**Subject:** NewHope Academy LUV Amendment- 3250 N. Arlington Heights Rd.  
Amendment to LUV Ord. 17-016

**PC#:** 21-015- Round 1

**PLAN COMMISSION PC #21-016**  
**NewHope Academy LUV**  
**3250 N Arlington Heights Rd**  
**Round 1**

# Appendix A

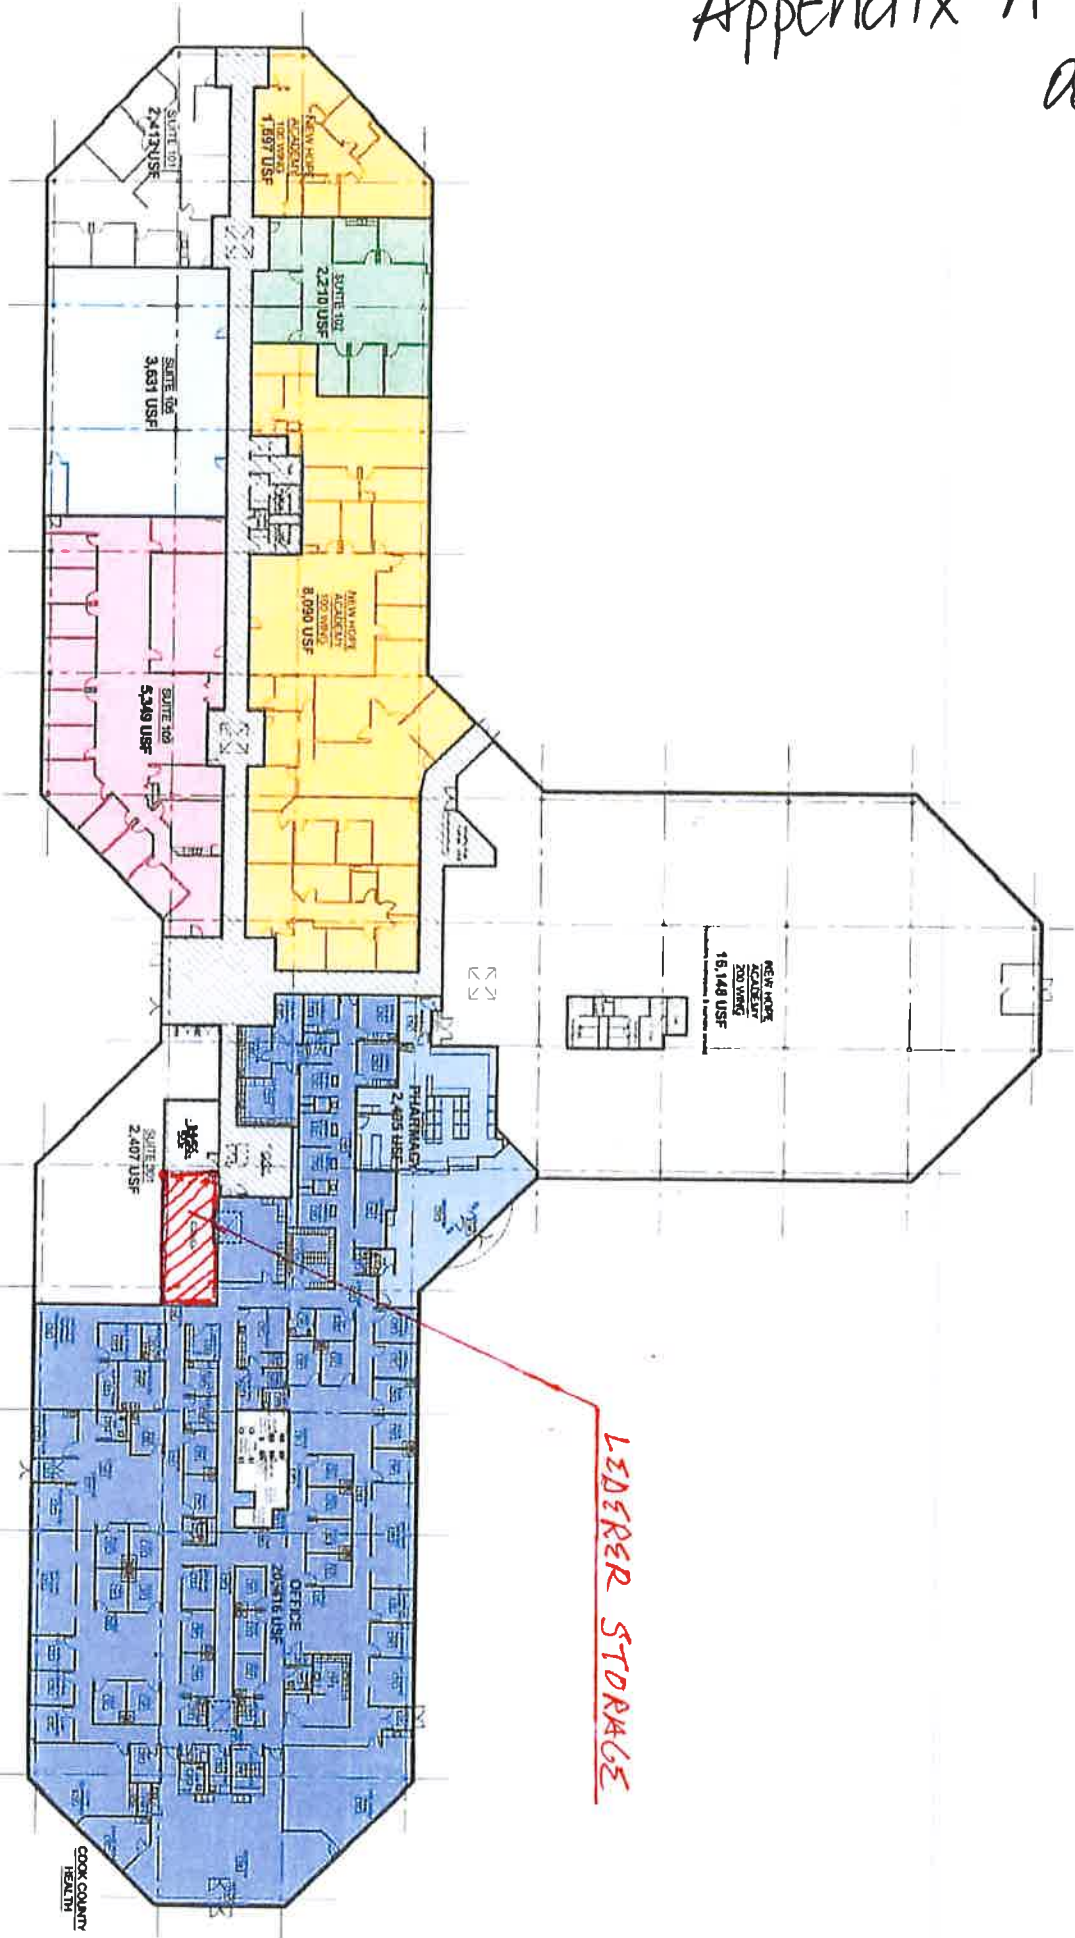
13. Please clarify where within the building the "Lederer Storage" Unit is located. This area was indicated on the 6/18/2021 "Leasing Report" but was not reflected on the Arlington Heights Corporate Center Area Plan. If this area no longer exists, please revise the Leasing Report.

The Lederer storage area consists of 608USF and is located in the 300 wing of the building. See attached area plan labeled **Appendix A.**

# APPENDIX C

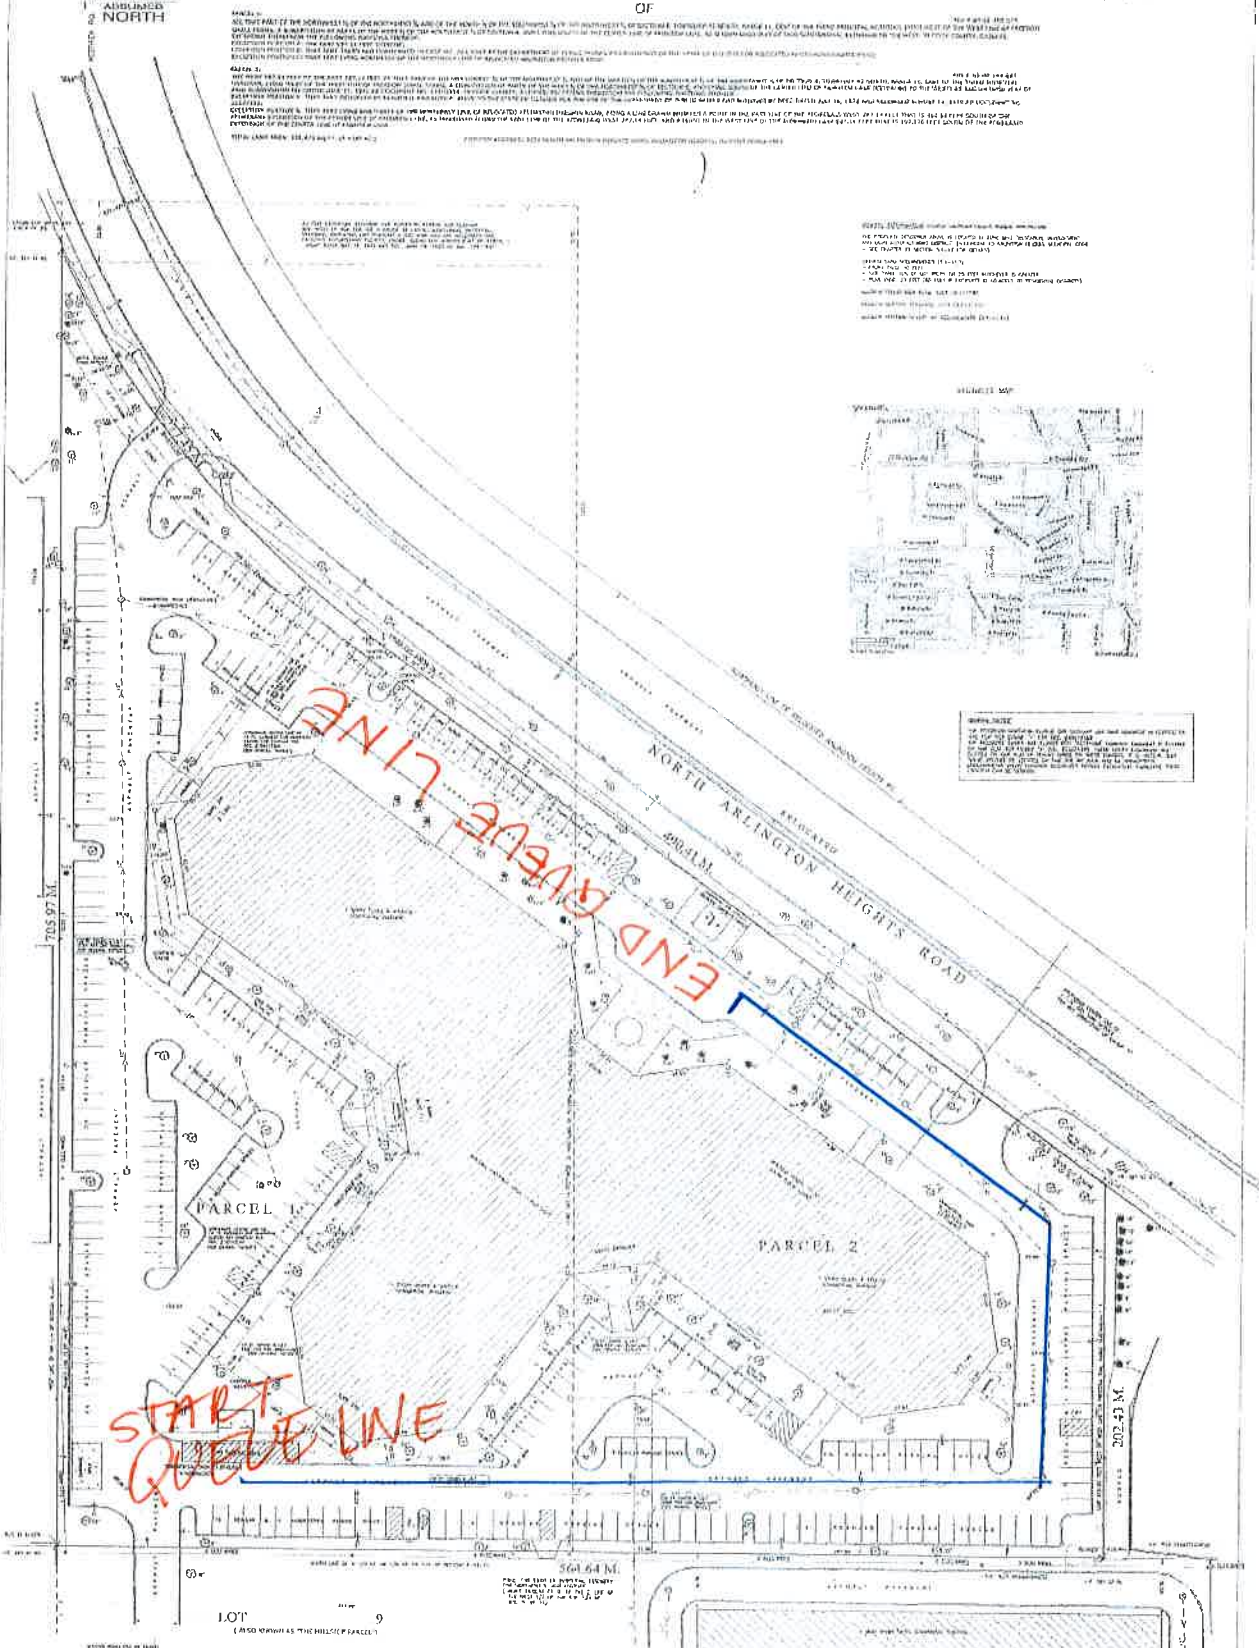
20. Please provide an exhibit showing the proposed location for the additional 15 "reserved" spaces and the location of the existing "reserved" spaces, as well as the extent of the peak drop-off/pick-up stacking queue observed by KLOA.

Reflected in the attached labeled **Appendix B and Appendix C.**
